### **CITY OF PORTLAND**

Remodle Kitchen and bath T l floor a add de

AT 40 MELBOURNE ST provided that the person or persons.

## **Staff Review Checklist**

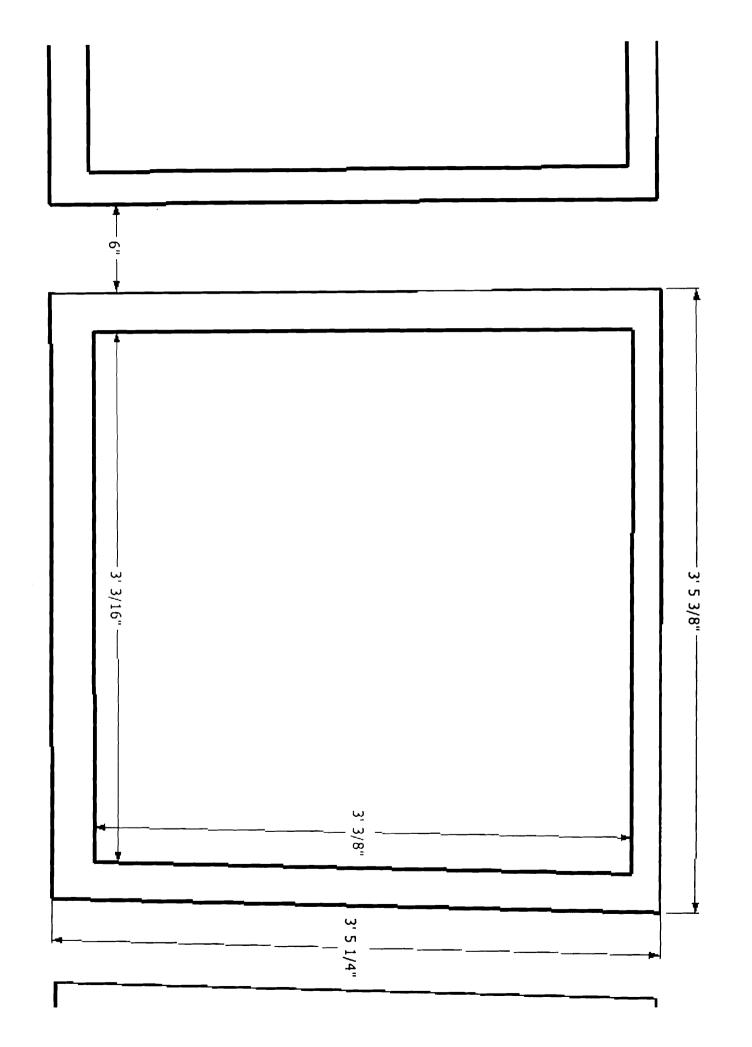
Pitch, Span, Spacing& Dimension (Table R802.5.1(1) - R 802.5.1(8)) Roof Rafter; Framing & Connections (Section R802.3 & R802.3.1)	3/12 Ritch 2×8 R-38	Ridge Boan to Be sized + spec & Needed. Ohis
Sheathing; Floor, Wall and roof (Table R503.2.1.1(1)	74 Advantac IRC - 2003	
Fastener Schedule (Table R602.3(1) & (2))	ILL - 2003	
Private Garage (Section R309) Living Space?	w/A	
(Above or beside)		
Fire Separation (Section R309.2)		
Opening Protection (Section R309.1)		
Emergency Escape and Rescue Openings (Section R310)		
Roof Covering (Chapter 9)	Aspalt w I/w 2 wordows by Stairs	
Safety Glazing (Section R308)	2 wondows by States	
Attic Access (Section R807)		
Chimney Clearances/Fire Blocking (Chap. 10)		
Header Schedule (Section 502.5(1) & (2)	17	*
Energy Efficiency (N1101.2.1) R-Factors of Walls, Floors, Ceilings, Building Envelope, U-Factor Fenestration	R-38 R-19	
Type of Heating System
